Service-Information Motorcycle

Group: 34
Brakes

February 1990
34 021 90
(2395)

Rear Drum Brake Shoes - All Models from 1981 on, except R80G/S

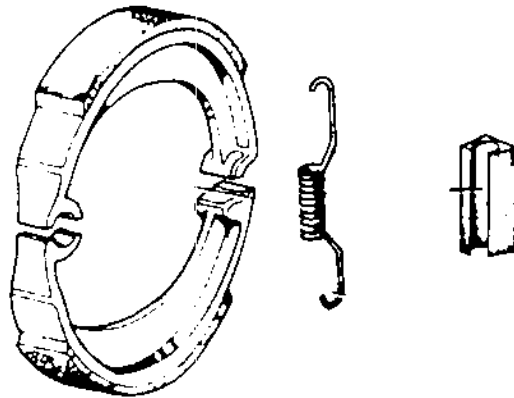
A new part number for asbestos-free brake shoes has been introduced for all rear drum brake models from model year 1981 and onward, with the exception of the R80 G/S (1981 - 1986).

This part number is a kit containing upper and lower brake shoes, 2 brake return springs, and a rubber absorber which can now be installed on the rear return spring in order to reduce the vibration of the spring which causes the squealing noise during braking.

Part Number 34 21 2 310 523
